Proponent's Response to Durham Region

SBA-01-25

November 6, 2025

We are writing in response to the comments from Durham Region regarding the proposed digital signage at **1629 Victoria Street East, Whitby, ON**. We have made every reasonable effort to meet the Region’s requests and align with established best practices across comparable and larger municipalities, including adherence to industry-accepted setback standards.

Revised Location: 146 metres from the stop bar (west side)

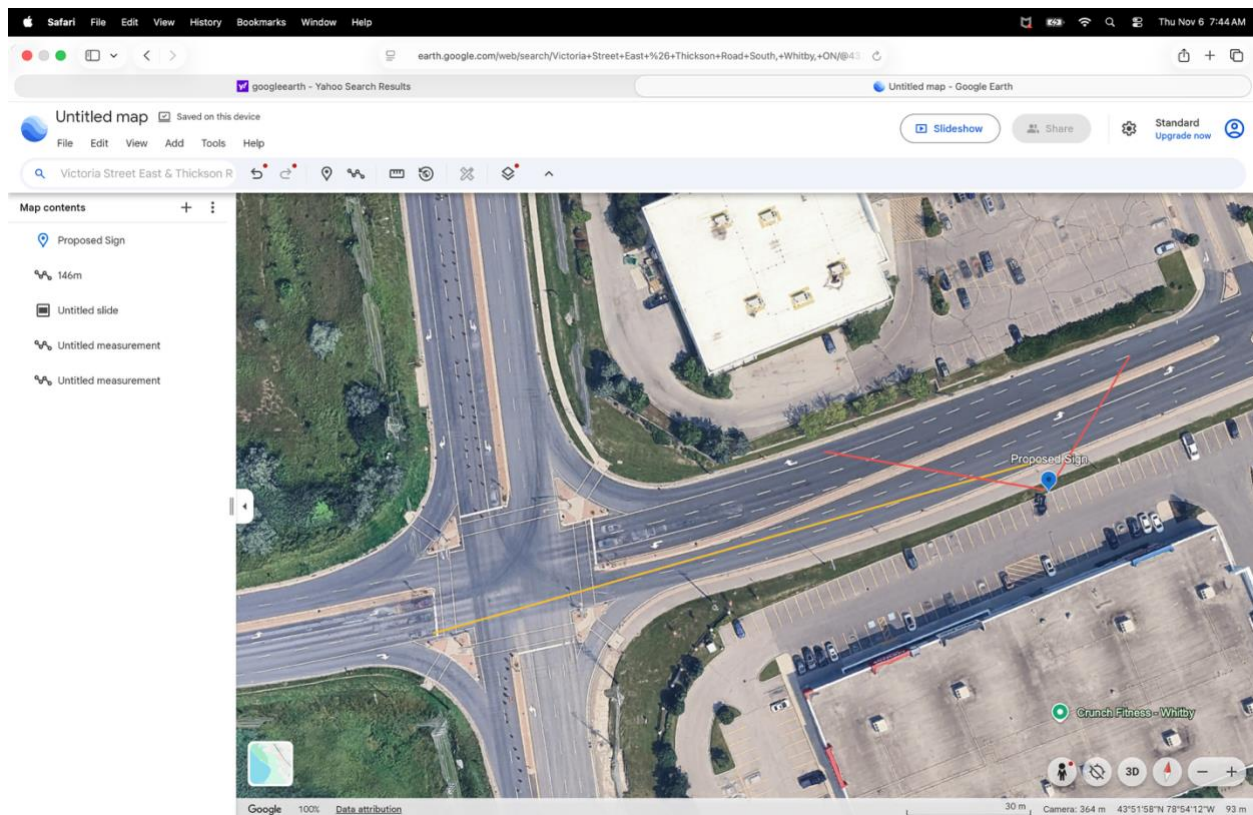
1. The Region does not support the proposed sign at this location. The intersection of Victoria Street East and Thickson Road South is ranked #2 in the Region’s intersection network screening for collision risk, indicating one of the highest safety priorities across the regional network. TAC advises against locating changeable digital displays within or near intersection influence areas because any visual distraction can exacerbate existing conflict patterns. The proposed digital billboard is positioned only about 124 m from the stop bar on a 60 km/h curved approach, placing it directly within the driver’s forward cone of vision during critical approach and decision phases. Introducing a high-luminance, changeable display in this environment would undermine ongoing Vision Zero and network safety efforts and is inconsistent with TAC’s siting principles for digital advertising displays

- a) The sign to be relocated outside the intersection influence area (target \geq 200–250m from the stop bar) to remove it from the decision zone

b) Orient and shield the centre-mount V so neither face directly addresses the stop bar or turning drivers on any approach, and add directional louvres.

We respectfully disagree with the Region’s interpretation of TAC’s guidance. The proposed display is positioned 146 metres from the stop bar, well beyond the intersection influence area and outside any applicable “cone of vision.” Traffic at this distance has already cleared the intersection, meaning the sign cannot be viewed by drivers during critical decision making phases. We would welcome the opportunity to review the Region’s technical assessment together to ensure full alignment and understanding of TAC’s definitions and applications in this case.

Our relocation to approximately 146 metres exceeds those standards. The sign is oriented away from the intersection and angled to eliminate visibility from the stop bar. We therefore believe this adjustment demonstrates our willingness to align with reasonable regional expectations.

There is no direct line of sight from the intersection or for turning movements. As such, additional shielding or louvres would not serve a functional purpose. We are, however, open to further dialogue should the Region wish to review photometric or sightline diagrams to confirm this conclusion.
